23-00399-00-MG

Maint. Garage Locker Room Addition - Milan Yard

This addendum forms a part of the bidding and contract documents. This Addendum supersedes and supplements all portions of the original bidding and contract documents dated 10/21/2024, with which it conflicts.

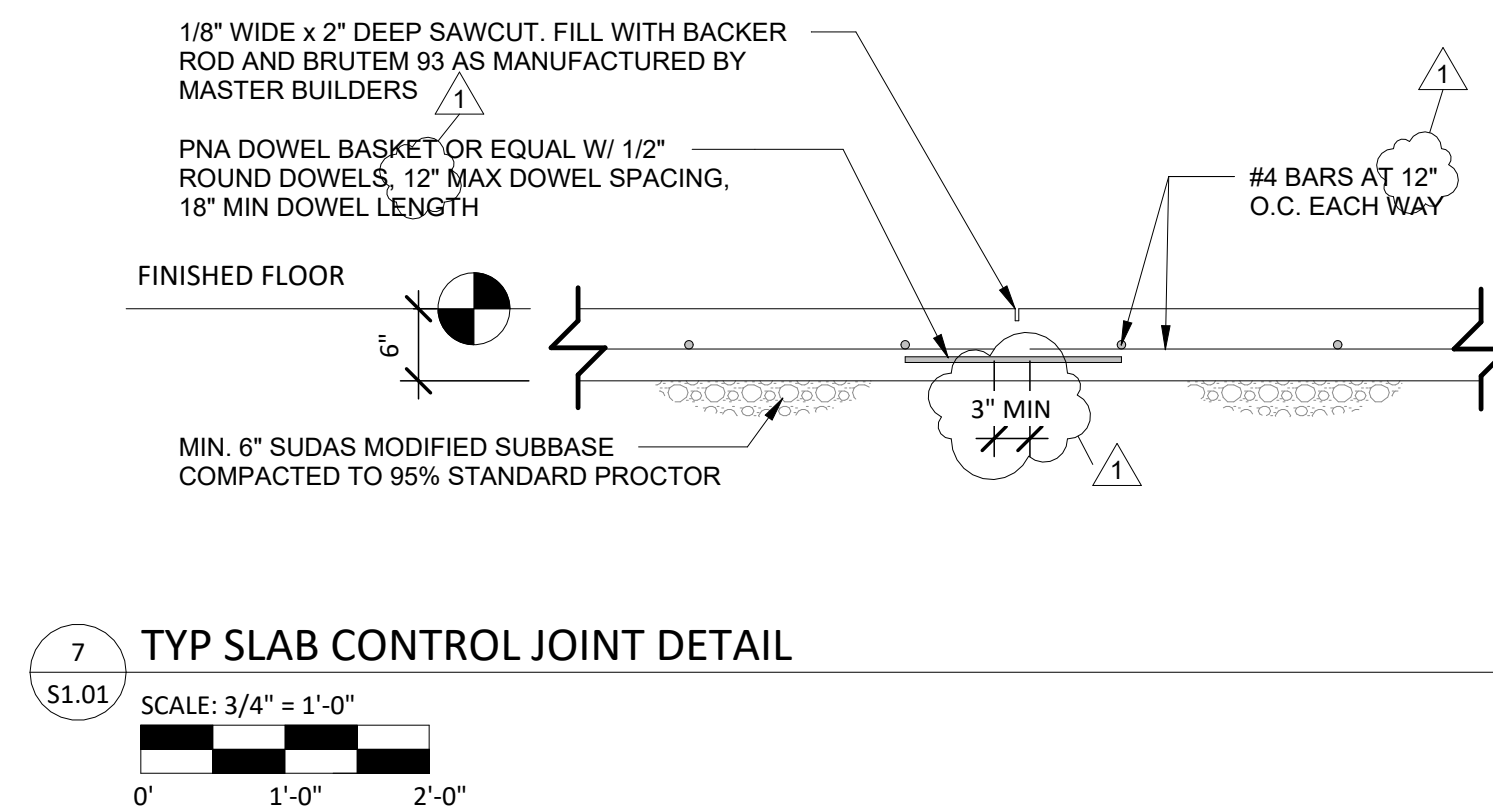
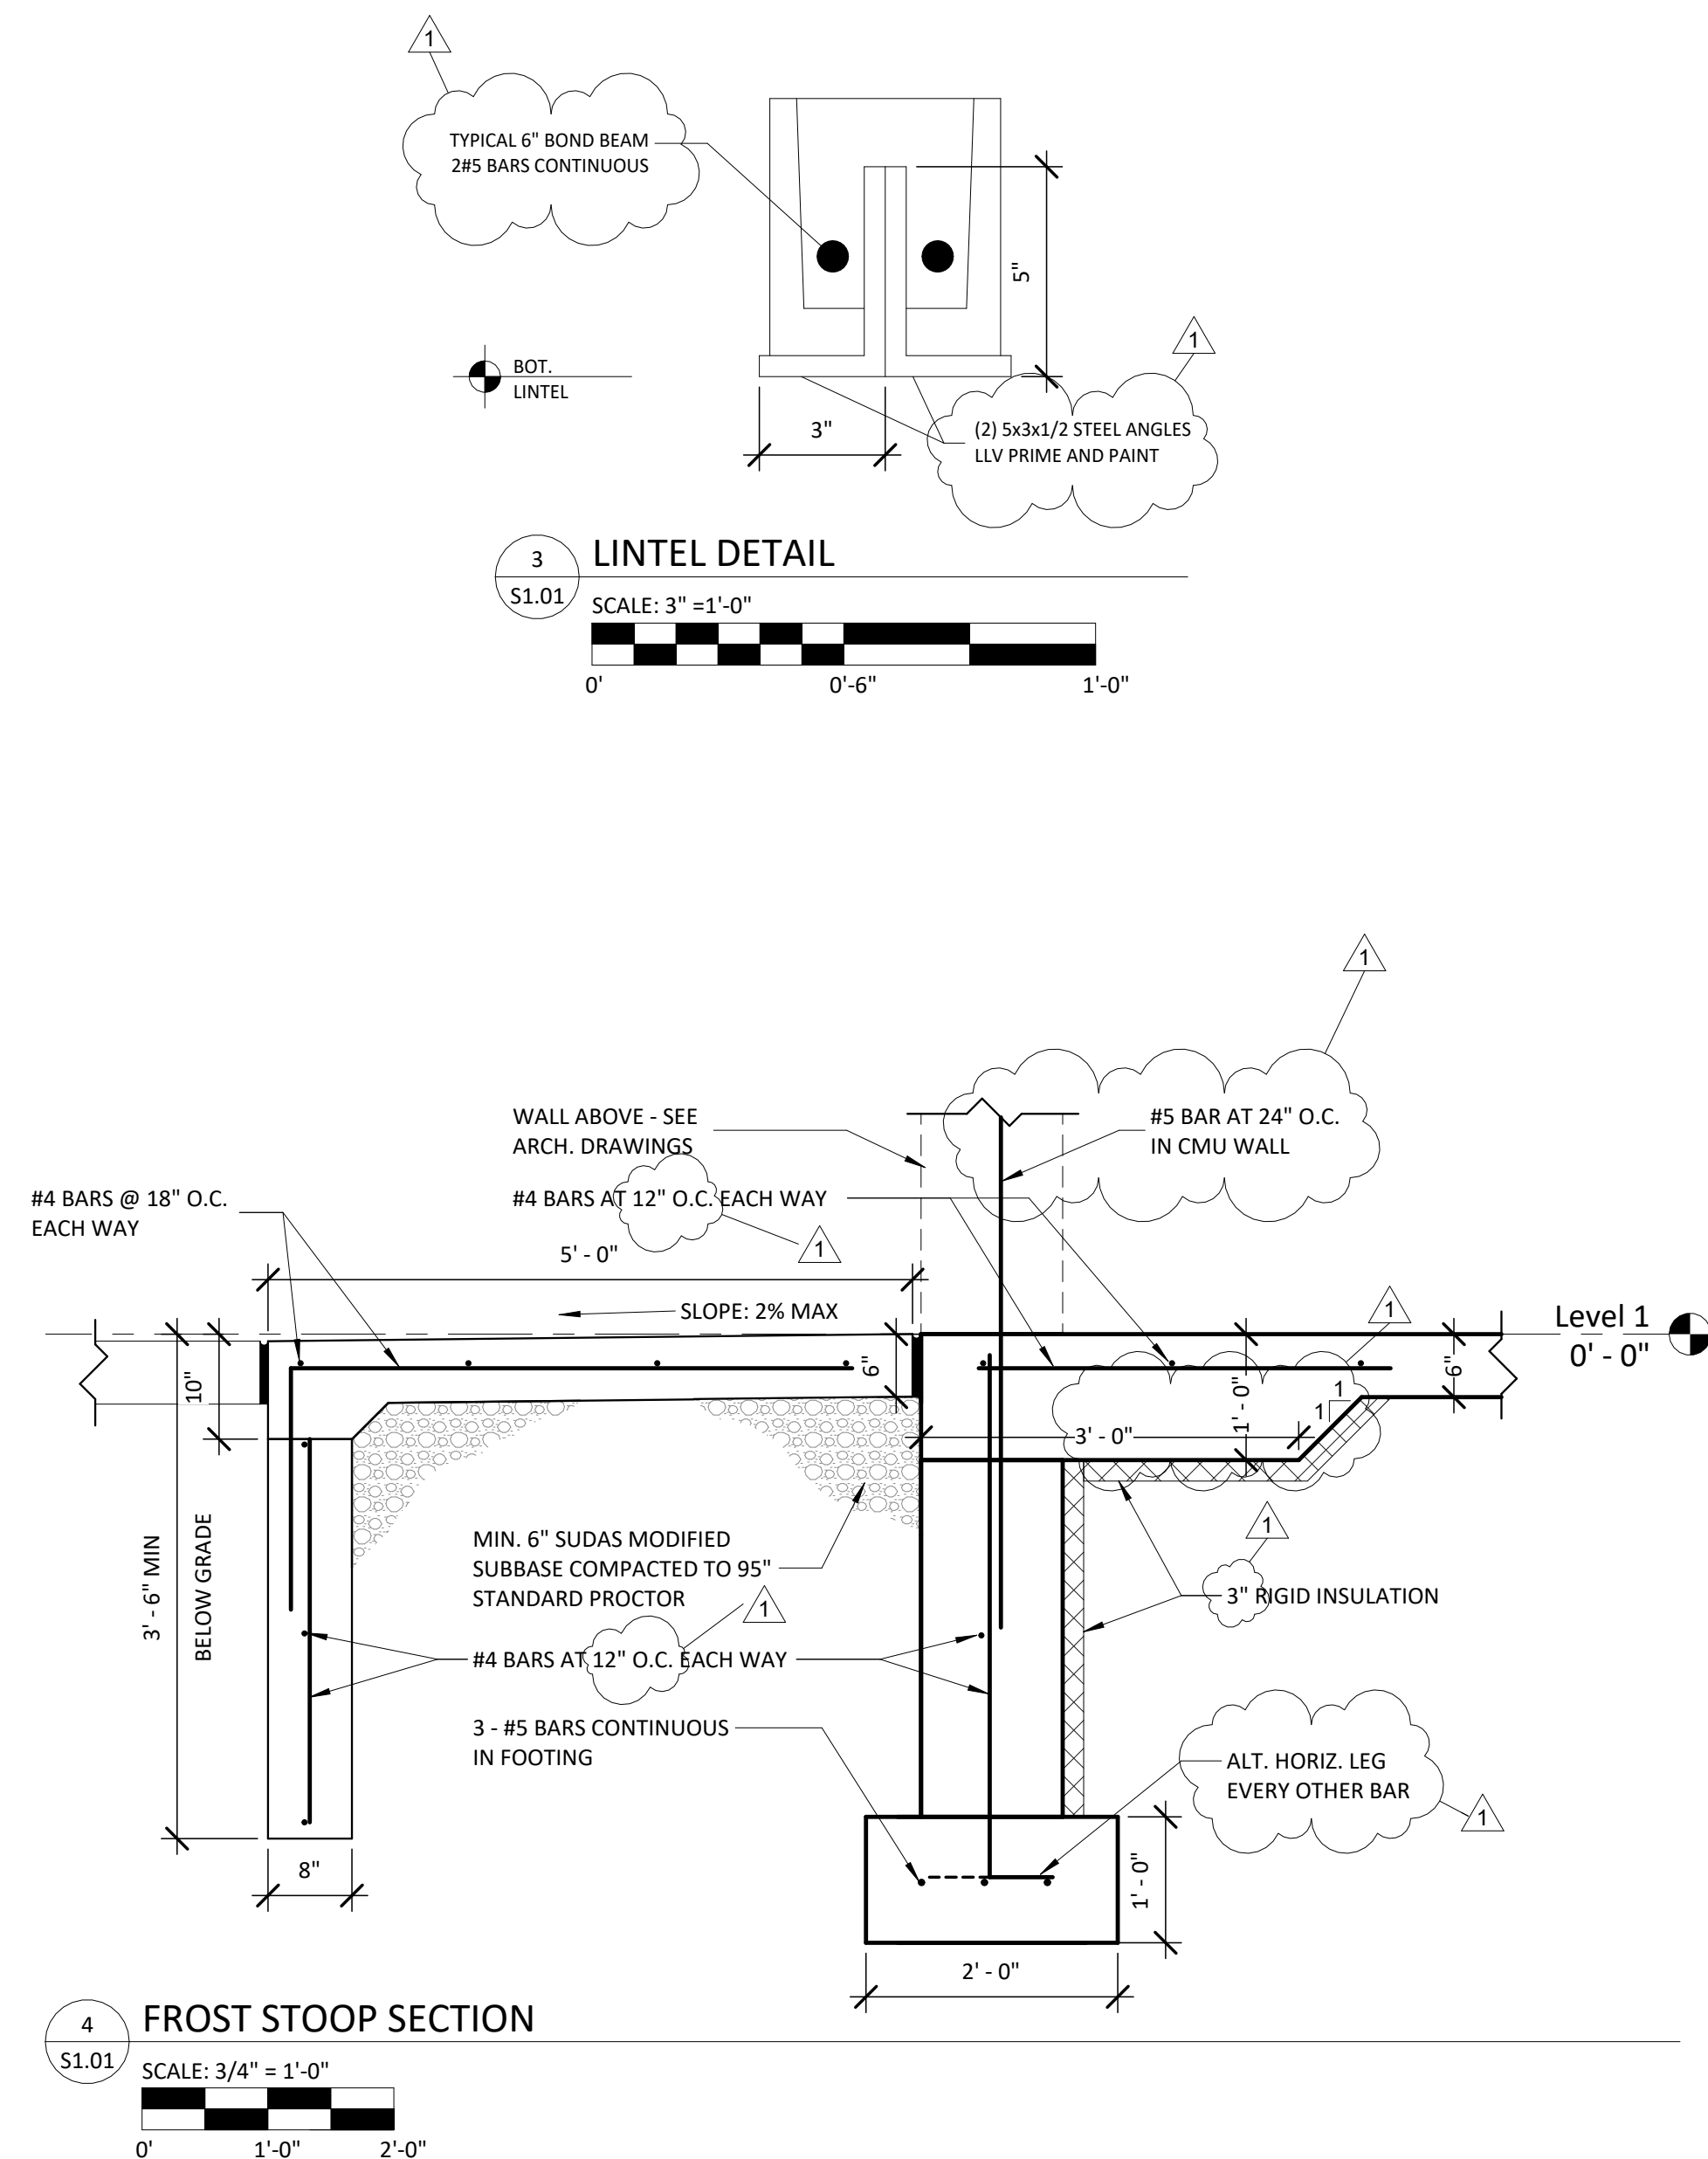
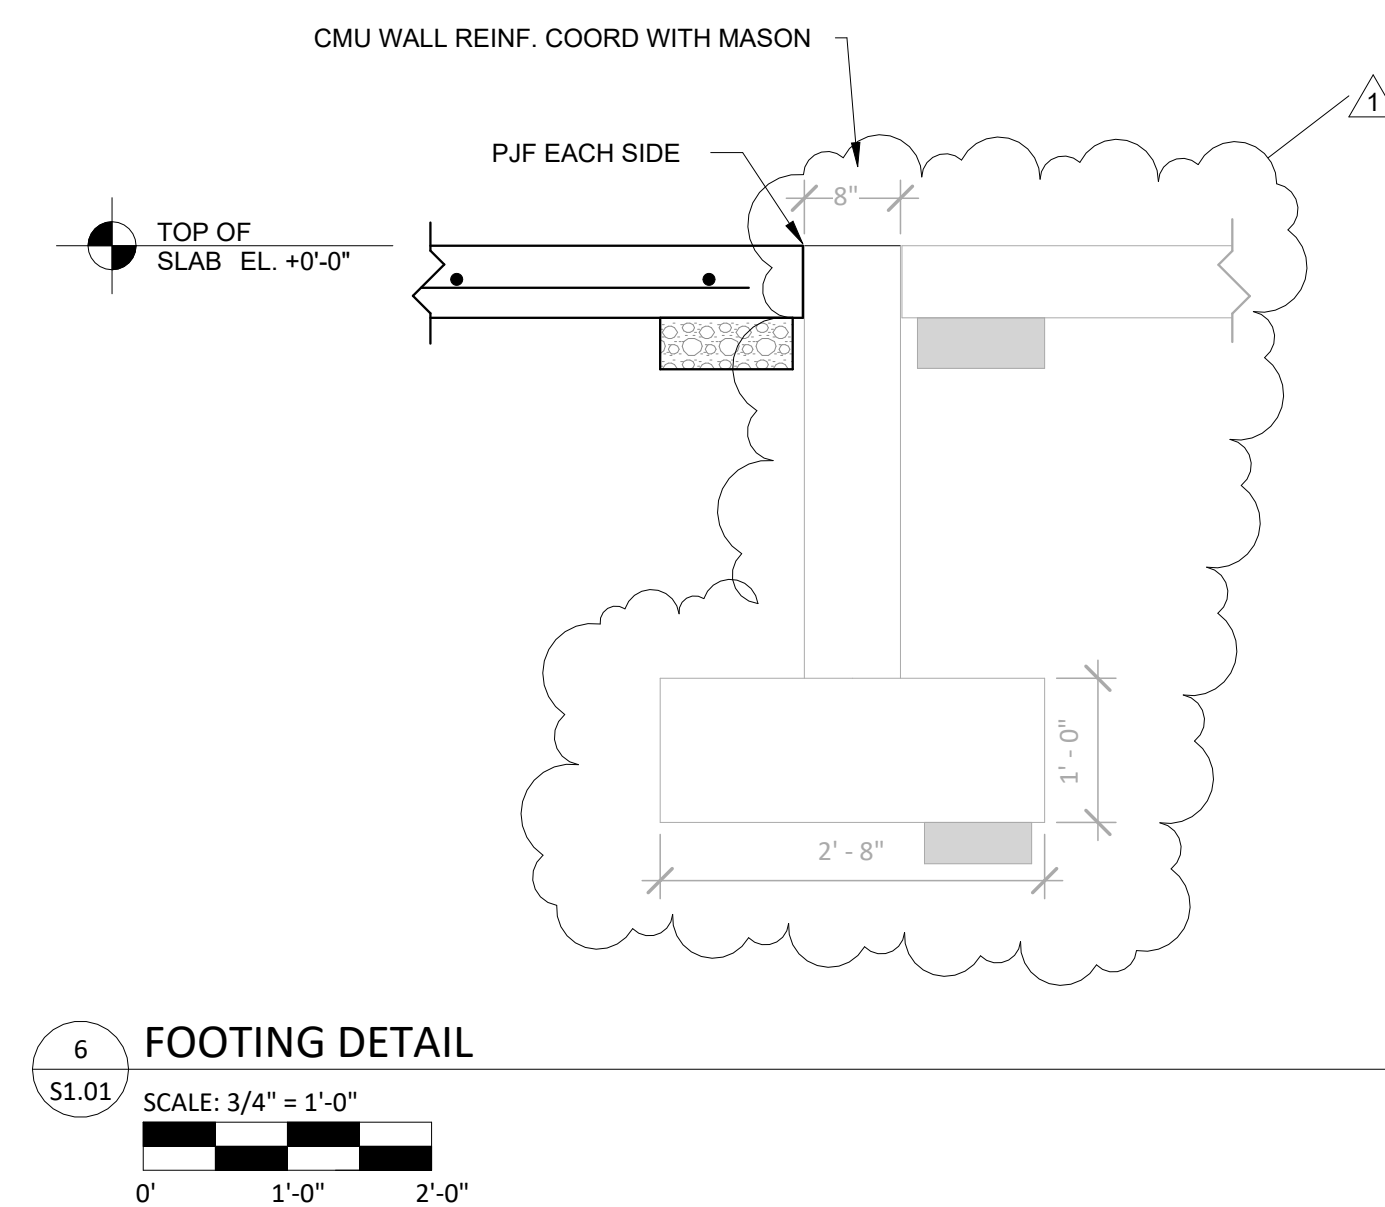
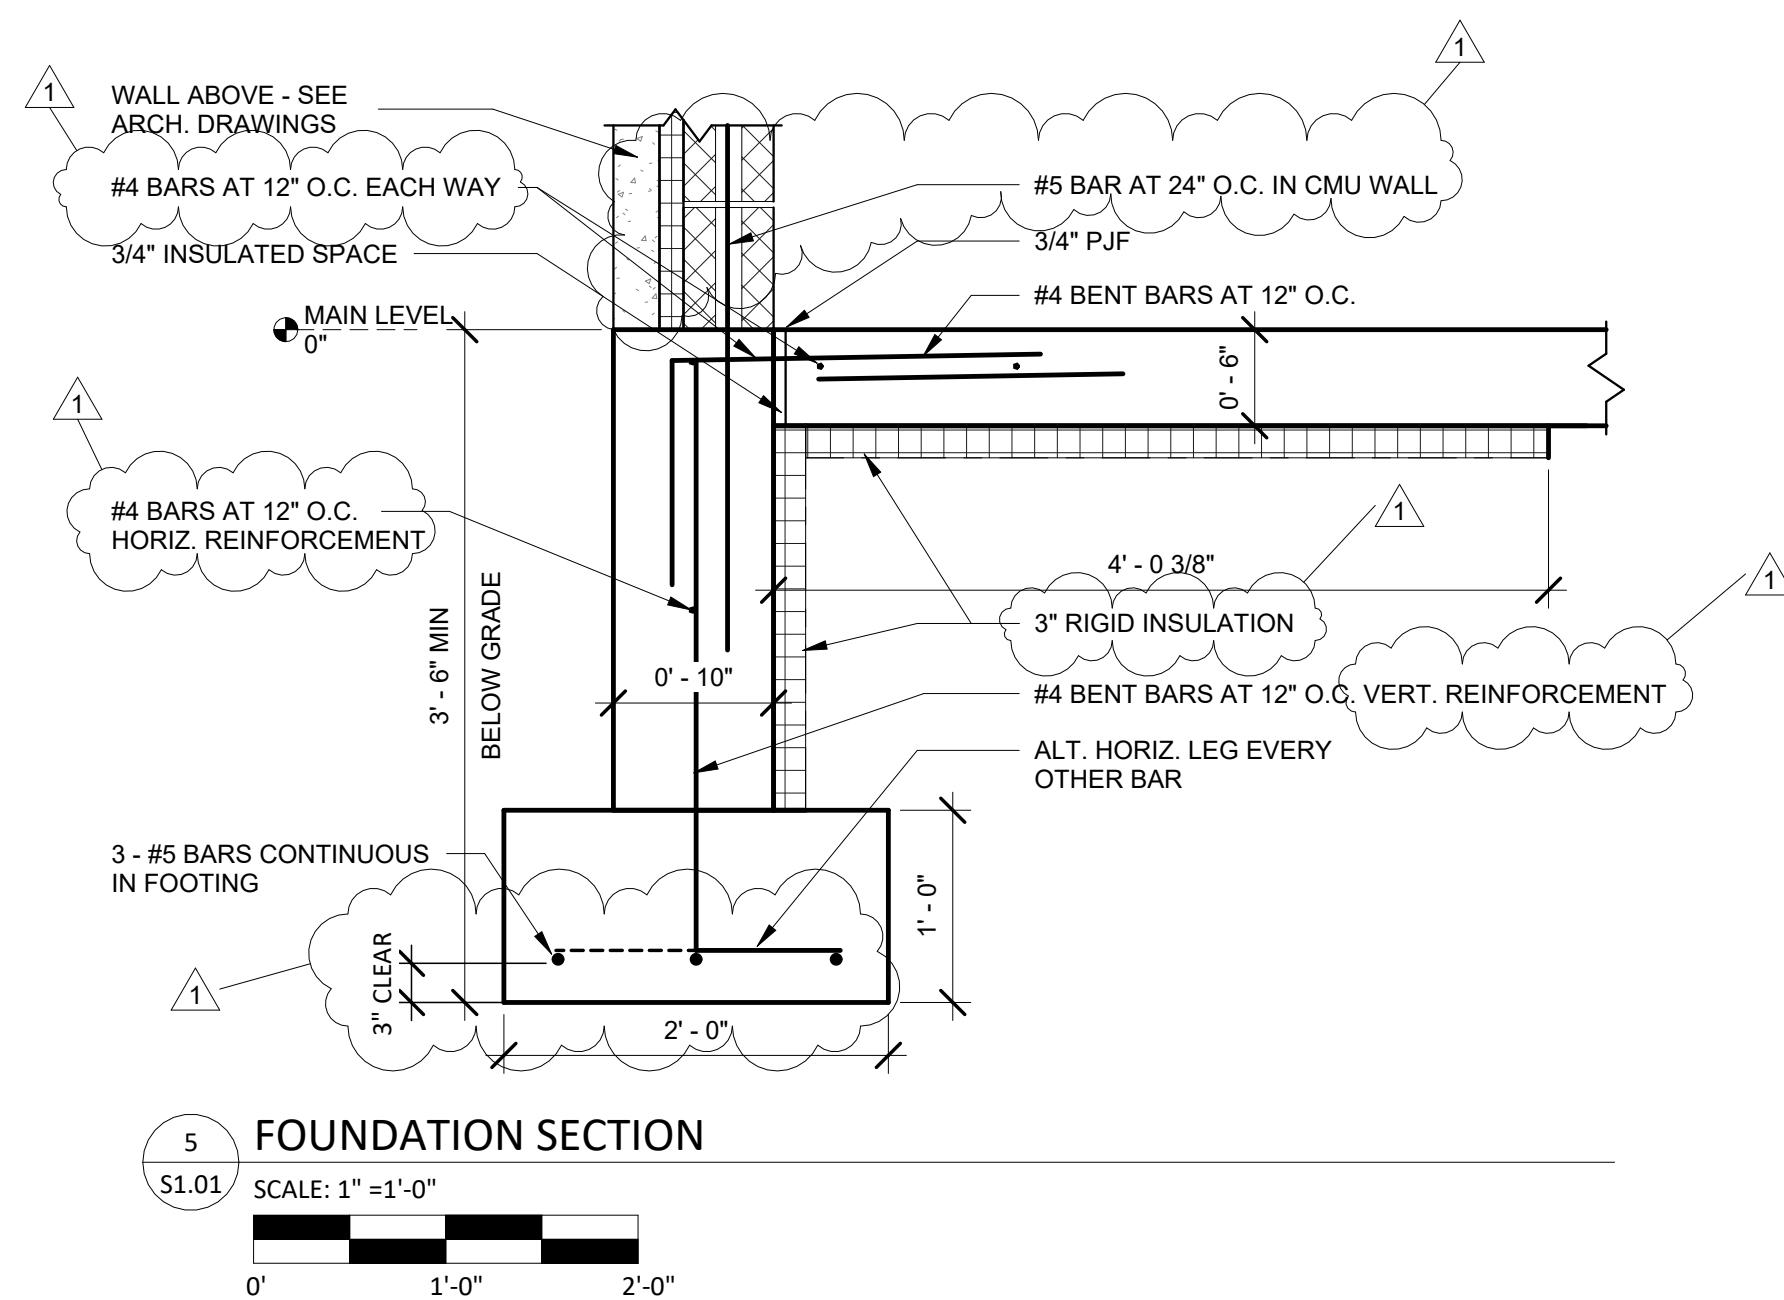
- a. 1/S1.01 – New Foundation Plan
 - i. **CHANGE** detail callout tag 3/S1.02 to 2/S1.02 SIM
 - ii. **ADD** section cut reference 5/S1.01
 - iii. **ADD** section cut reference 6/S1.01

- b. 2/S1.01 – New Roof Structure
 - i. **ADD** note that reads “1 ½” 18 GA. METAL DECK”
 - ii. **ADD** note that reads “METAL DECK TO RUN PERPENDICULAR TO STEEL FRAMING MEMBERS”

- c. 3/S1.01 – Lintel Detail
 - i. **CHANGE** bond beam size to 6”
 - ii. **CHANGE** steel angle dimensions to 5”x3”x1/2”
- d. 4/S1.01 – Frost Stoop Section

- iv. **CHANGE** rigid insulation thickness to 3”
 - v. **ADD** note that reads “ALT. HORIZ. LEG EVERY OTHER BAR”
- e. 5/S1.01 – Foundation Section
 - i. **ADD** architecture wall elements with rebar and note that reads “#5 BAR AT 25” O.C. IN CMU WALL”

- v. **ADD** “VERT. REINFORCEMENT” to “#4 BENT BARS AT 12” O.C.” note
 - vi. **CHANGE** rebar shown in footing and **ADD** “3” CLEAR” note
- f. 6/S1.01 – Footing Detail

- i. **CHANGE** linework to show existing footing elements
 - ii. **REMOVE** notes corresponding to existing footing elements
- g. 7/S1.01 – TYP Slab Control Joint Detail

- i. **CHANGE** dowel spacing to 12” MAX
 - ii. **CHANGE** #4 bar spacing to 12” O.C.
 - iii. **CHANGE** dimension to 3” MIN
- h. 8/S1.01 – TYP Slab Control Joint Detail1
